Charlotte Historic District Commission Application for a Certificate of Appropriateness

May 11, 2011

ADDRESS OF PROPERTY	1600 Wilmore Drive, Wilmore Local Historic District	HDC 2011-035
SUMMARY OF REQUEST	New Single Family Construction	
OWNER	Broadstreet Properties	
APPLICANT	Michael Iagnemma

Details of Proposed Request

SHEET TITLE
ELEVATIONS

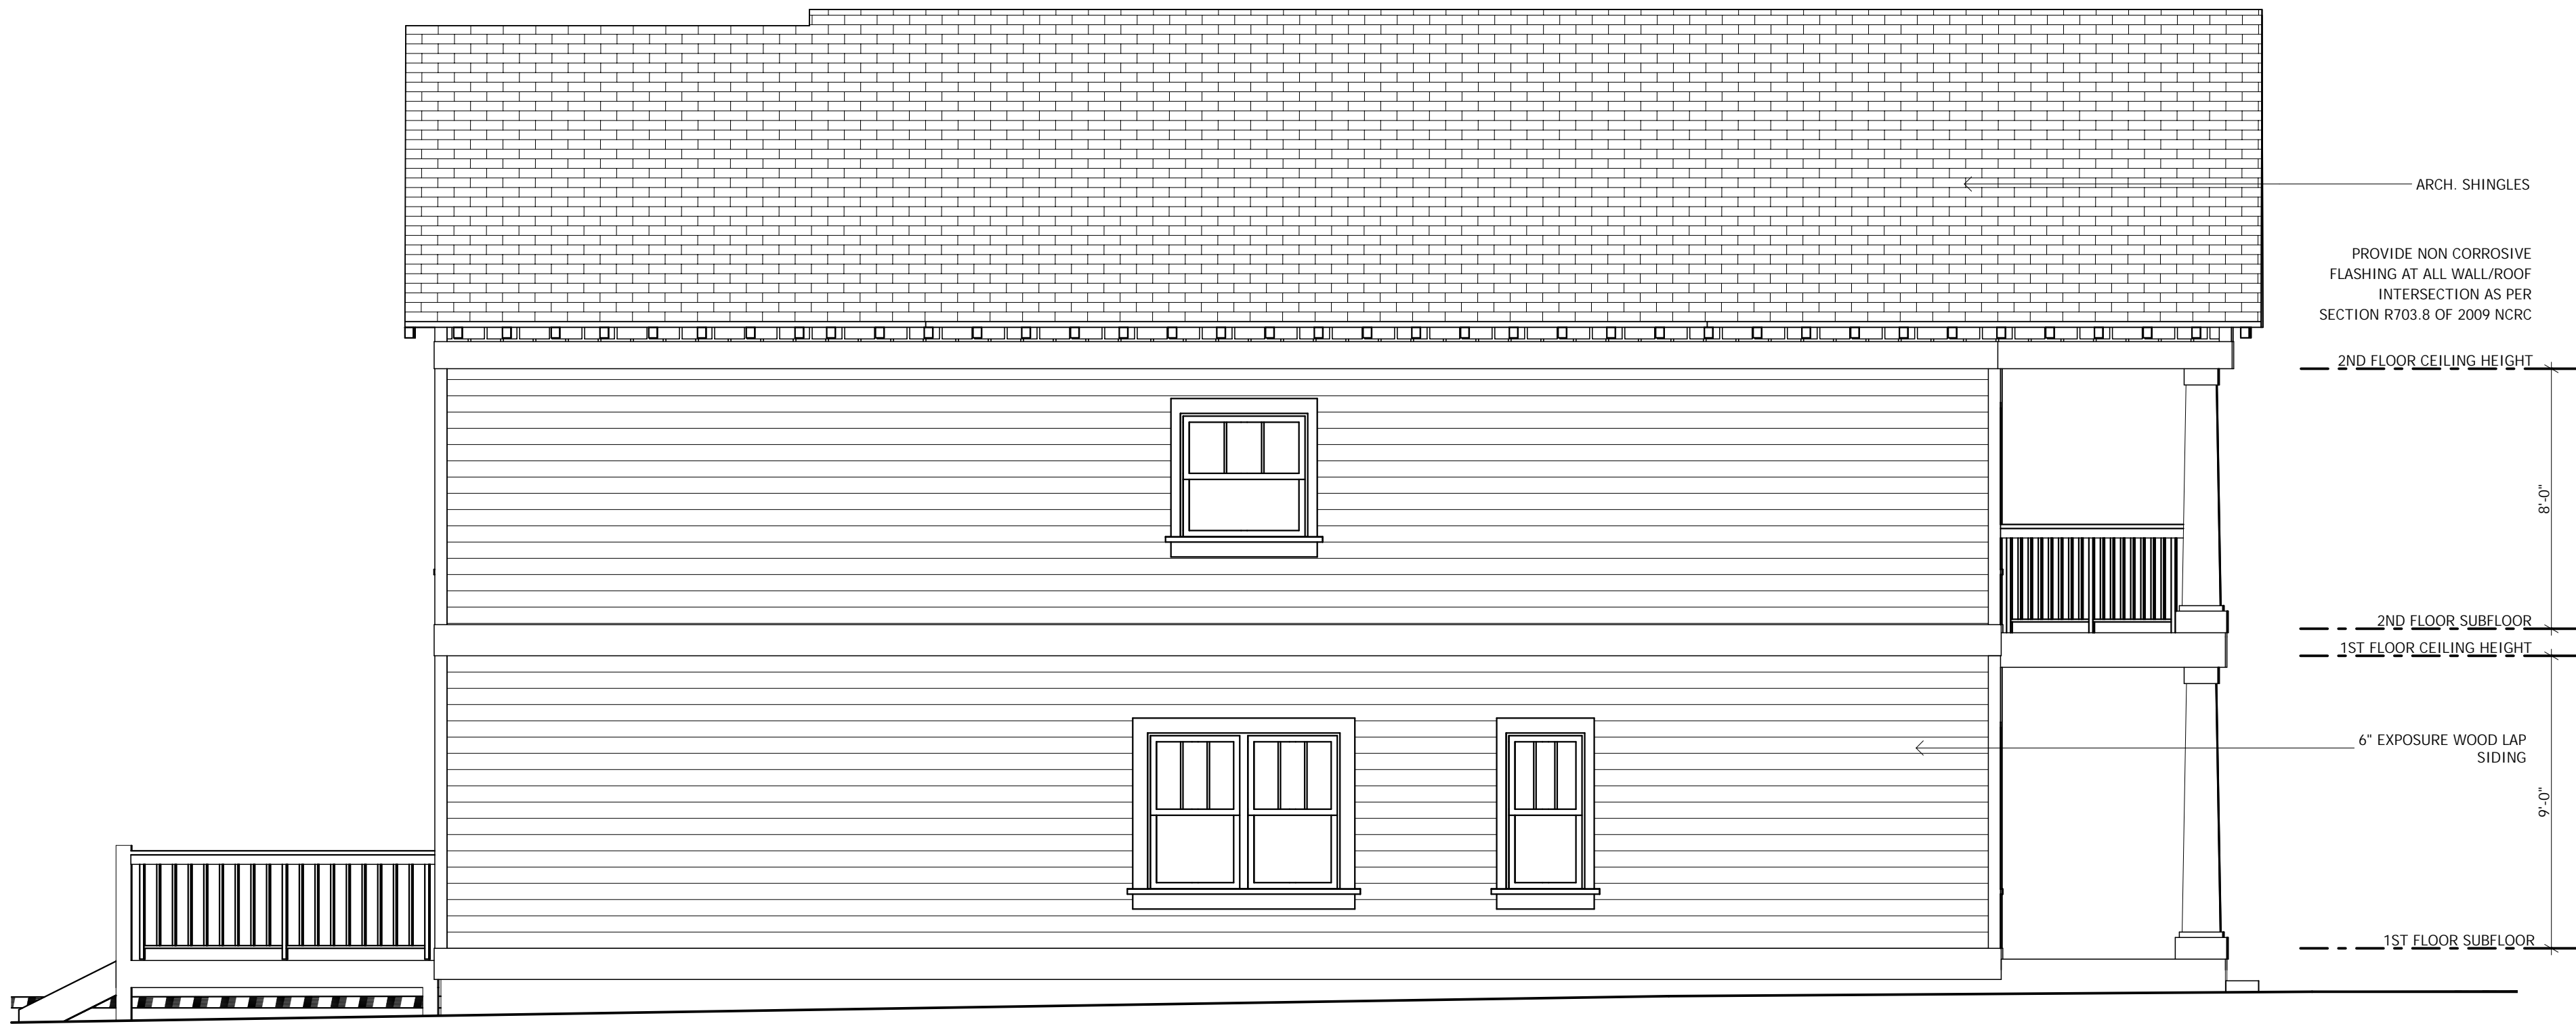
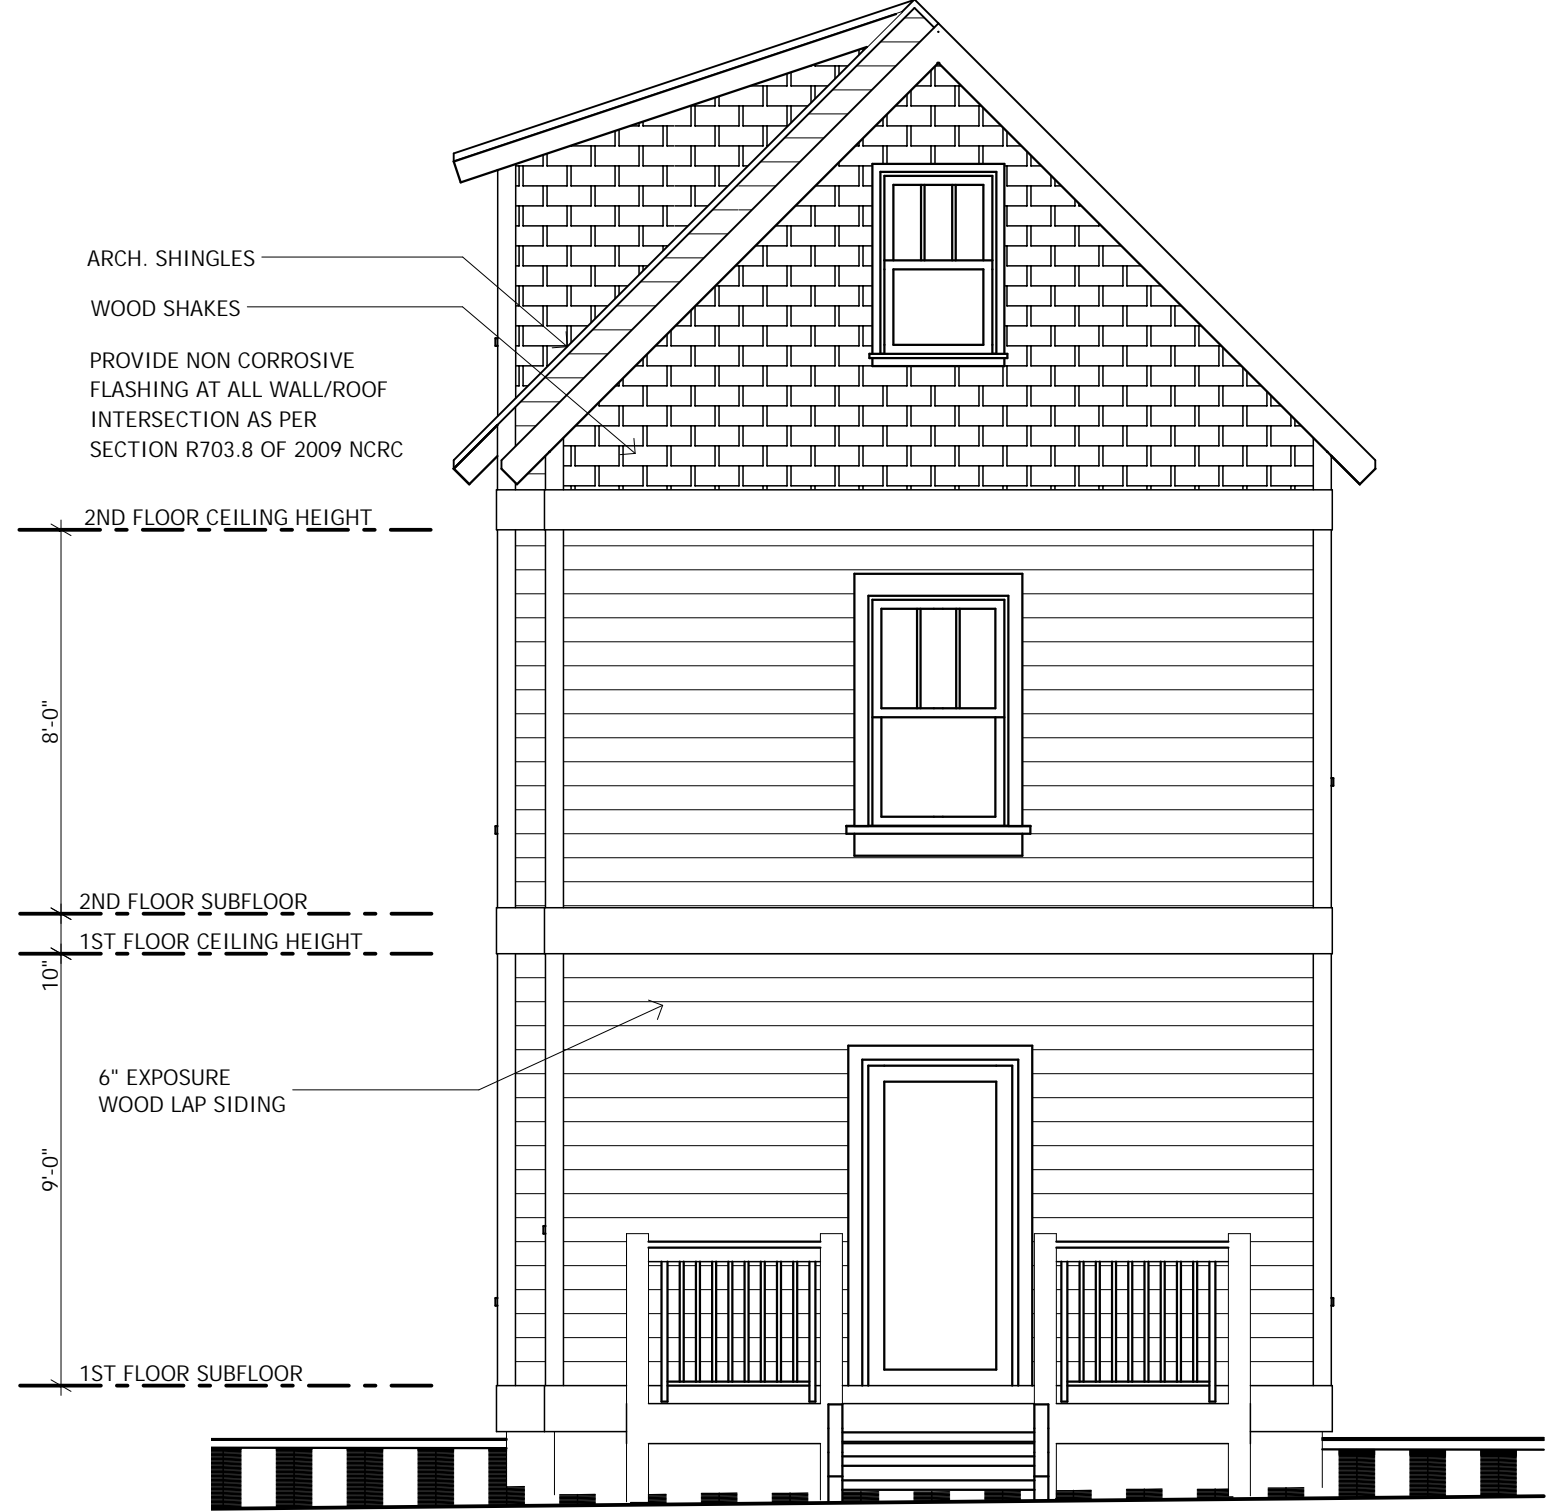
Due to the small size, odd shape and narrow configuration of this lot, the buildable envelope is very small for any new construction once the required setbacks are met. Consequently, the proposed new house is a narrow, two story structure with a full façade porch on both the first and second floors. The house has a gabled roof, with a centered shed dormer on the side street elevation.

The house is proposed to have lapped wood siding with a six inch exposure, and wood shakes above the main roof eave in the gable ends and on the shed dormer. There is a small rear deck.

The windows on the house are shown to me 3/1, which is a typical style for the period when Wilmore was primarily developed. There appears to be no note on the plans stating the materials of the proposed windows.
